Our ref: LT/2008/107067/01-L01
Your ref: 08/00553/ful

CREATION OF CANAL BOAT MARINA WITH ASSOCIATED LANDSCAPING LAND AT JUNCTION OF WELLSBOROUGH ROAD AND CONGERSTONE LANE MARKET HARBOROUGH LEICESTER

We **Object** to the proposed development as the Flood Risk Assessment (FRA) included within the EIA document dated September 2008, received by yourselves on 17 December 2008, is currently unacceptable to us for the following reasons: -

Section on A - A

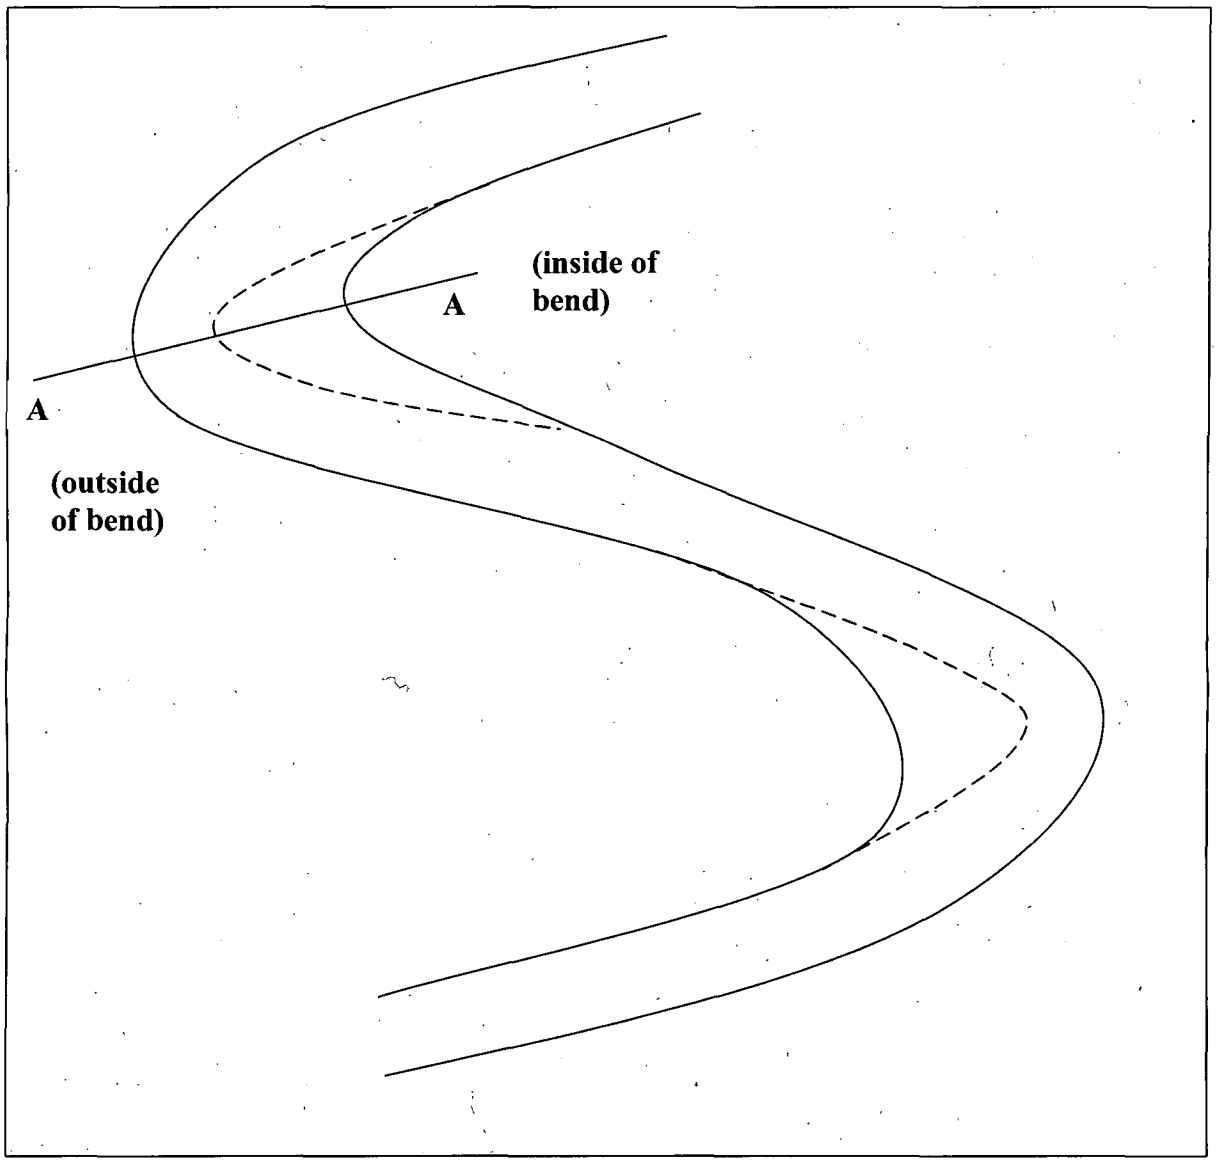
3. The applicant should profile the banks of the stream that runs through the site as a tick-shaped channel, this will improve the structure and the associated biodiversity (see attached drawing).
